Project: Supply and delivery of construction materials for 9 Repairs of Public Infrastructure and Utilities, Northwest, Chuuk, Federated States of Micronesia

Bid Bulletin No. 3

Responses and comments to general and technical requirements with regard to the ITB on Supply and delivery of construction materials for 9 Repairs of Public Infrastructure and Utilities, Northwest, Chuuk, Federated States of Micronesia

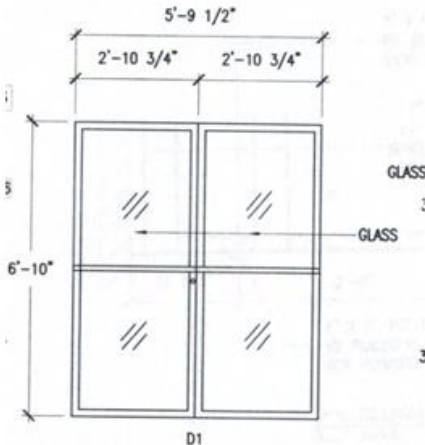
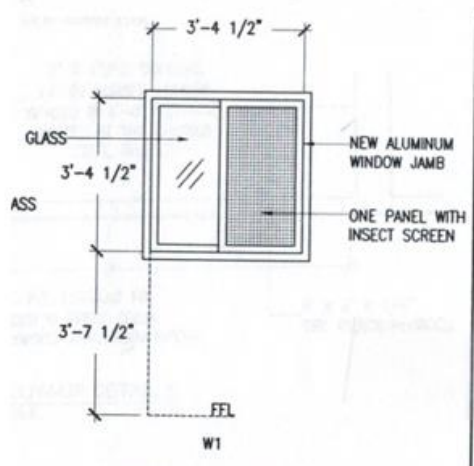
98	C-purlins 2"x4"x20' Ga. 14, HDG
99	C-Purlins, HDG, 1 1/2"x2"x20'x5/64"
100	C-Purlins, HDG, 1 1/2"x3"x20'x5/64"

101	C-Purlins, HDG, 2"x2"x20'x5/64"
102	C-Purlins, HDG, 2"x6"x20'x5/64"

Do you have any drawings for the above items?

IOM Response: Here please additional information and drawing:

98	C-purlins 2"x4"x20' Ga. 14, HDG		sample 2"x4"x20' Ga. 14, HDG			
99	C-Purlins, HDG, 1 1/2"x2"x20'x5/64"		a=2"			
100	C-Purlins, HDG, 1 1/2"x3"x20'x5/64"		b=4"			
101	C-Purlins, HDG, 2"x2"x20'x5/64"		c=20' (length)			
102	C-Purlins, HDG, 2"x6"x20'x5/64"		Ga. = Gauge (Thickness)	HDG = Hot dipped galvanized
